Proposal Request

PROPOSAL REQUEST 089

Green Roof Devices and High Roof Security Cameras

PROJECT: AWSOM
BENTONVILLE, AR

Contents:
**SECURITY -
LEVEL 5 PLAN -
ROOF AREA A**

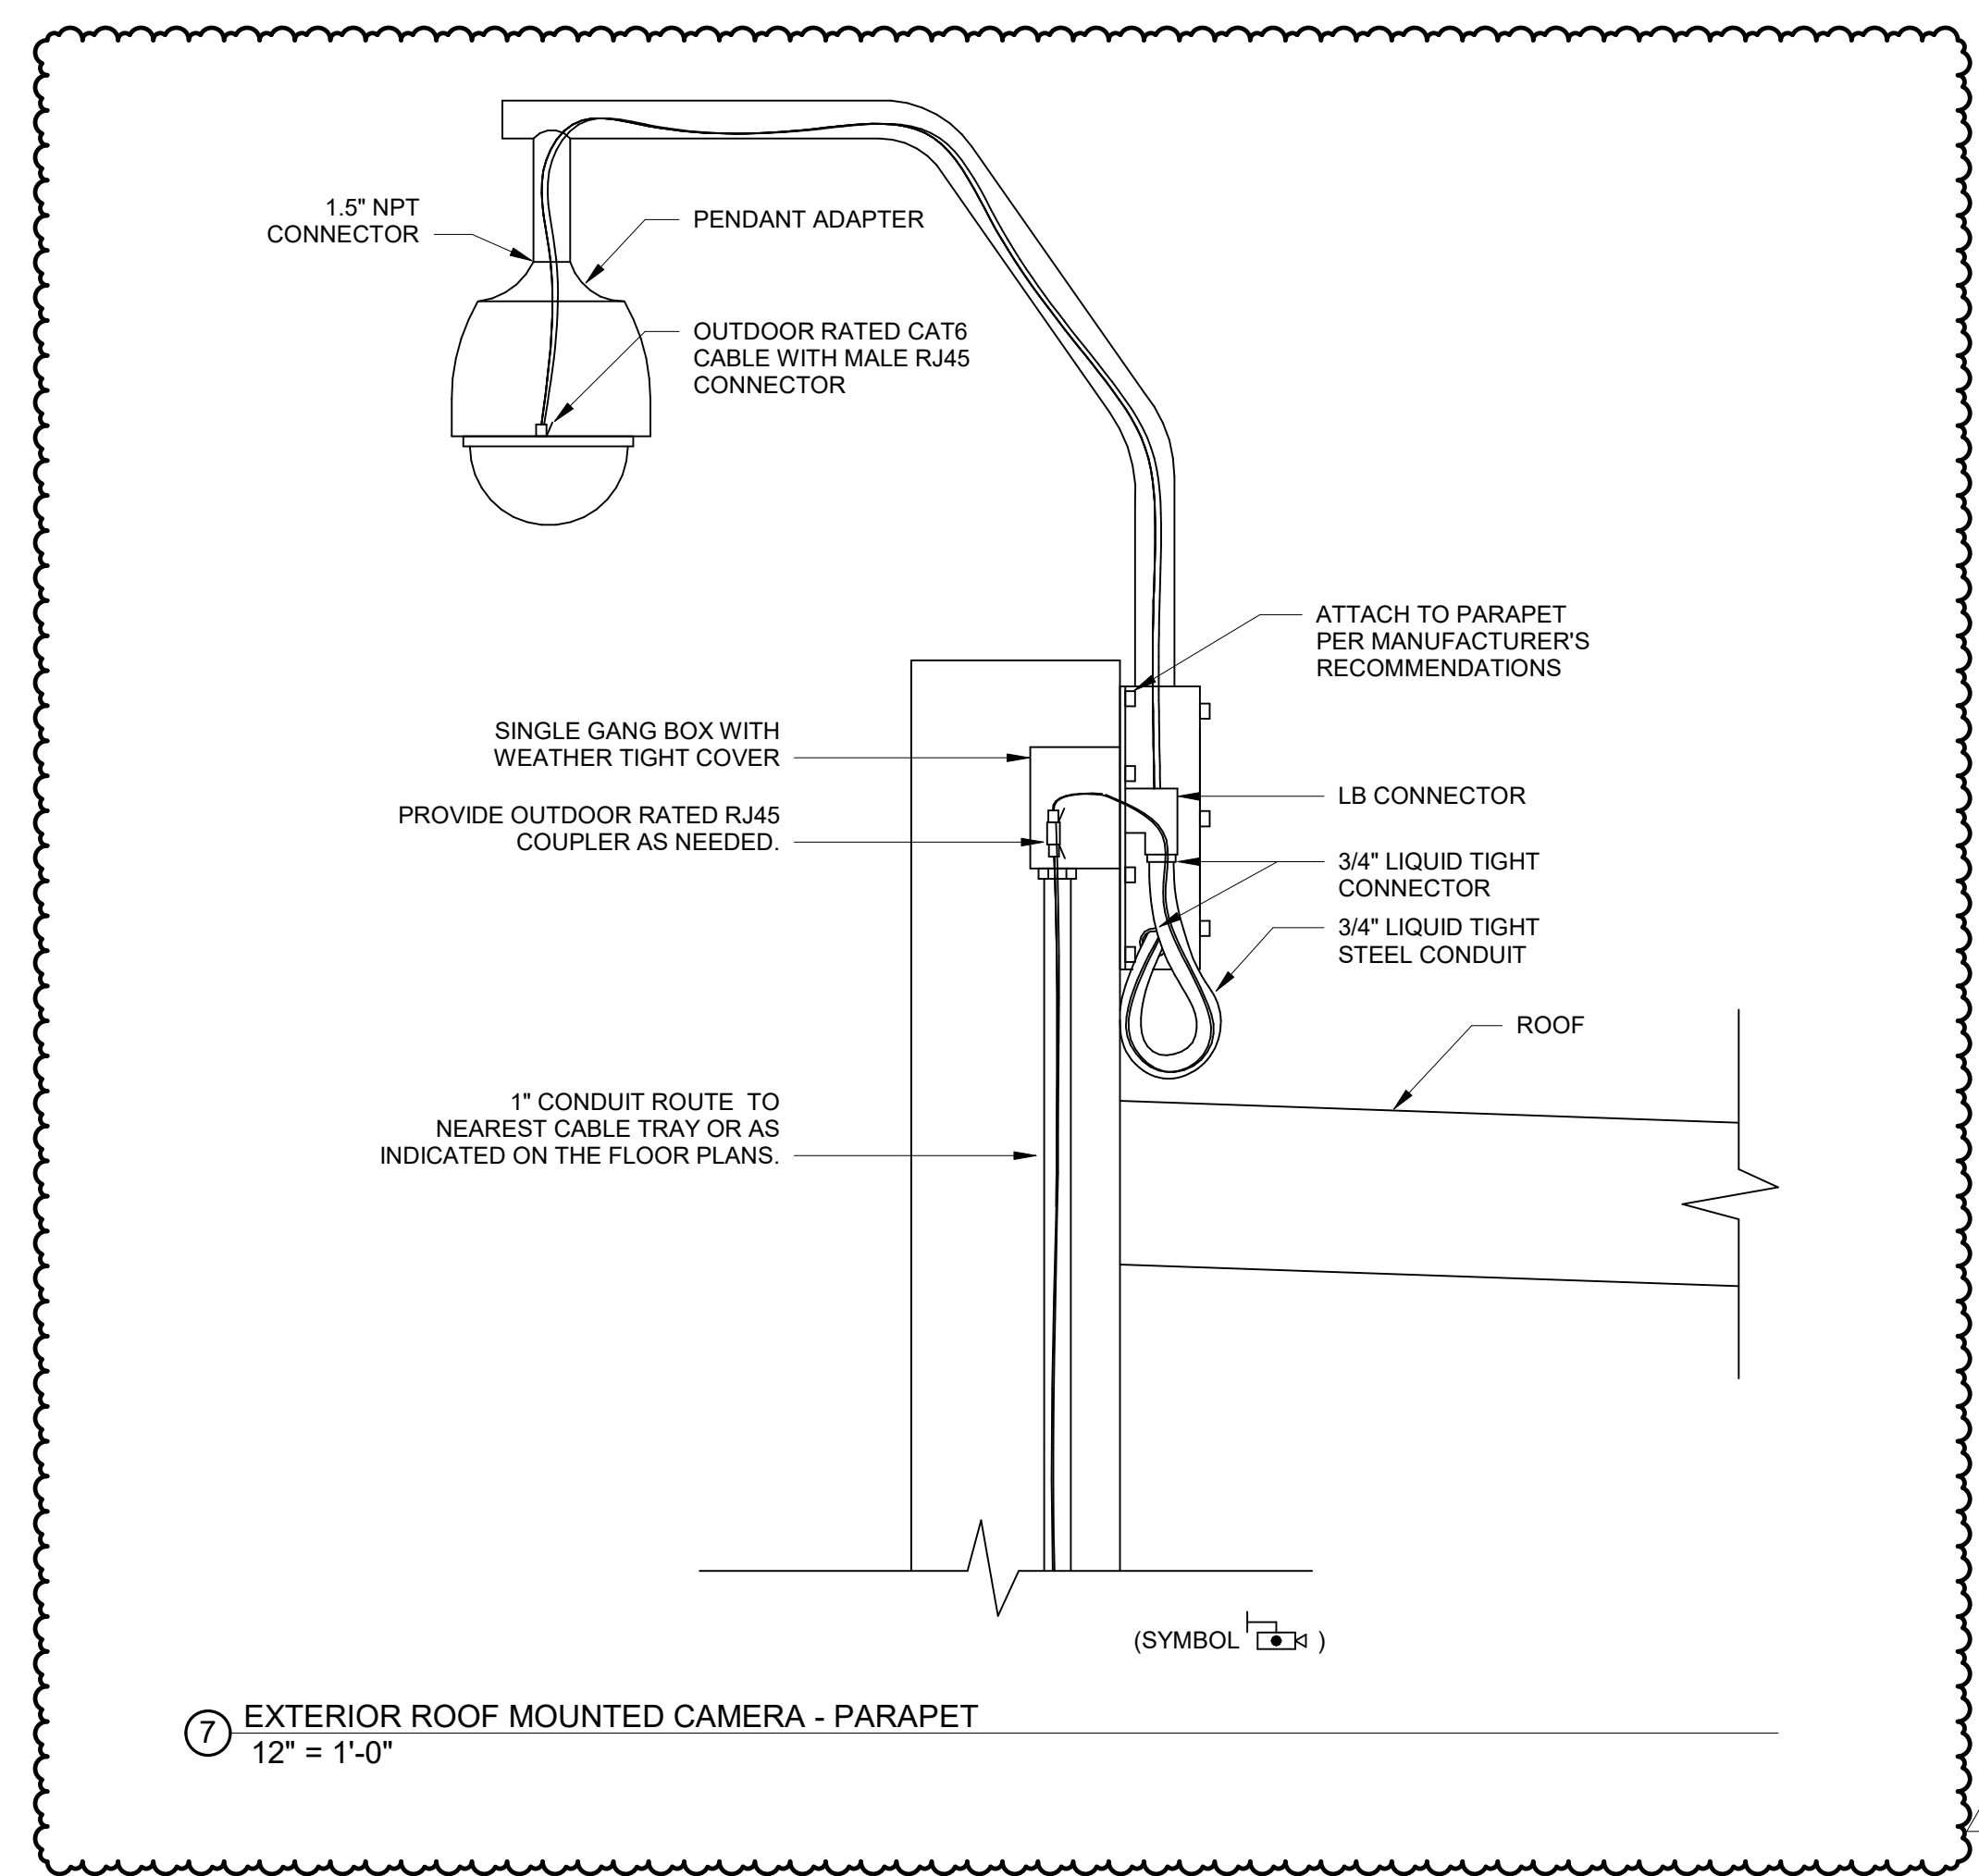
- a) Added Sheet **TY105A** with issue date 12.12.2024.
 - Added three cameras to Roof Plan – Section A for surveilling Green Roof, Area B, of Roof Plan. Revised mounting location of Northeast Rooftop Camera.
- b) Revised Sheet **TY500** with original issue date 02.24.2023 and revised date 12.12.2024.
 - Revised sheet to include Details for Parapet mounting guidelines for Rooftop Cameras.
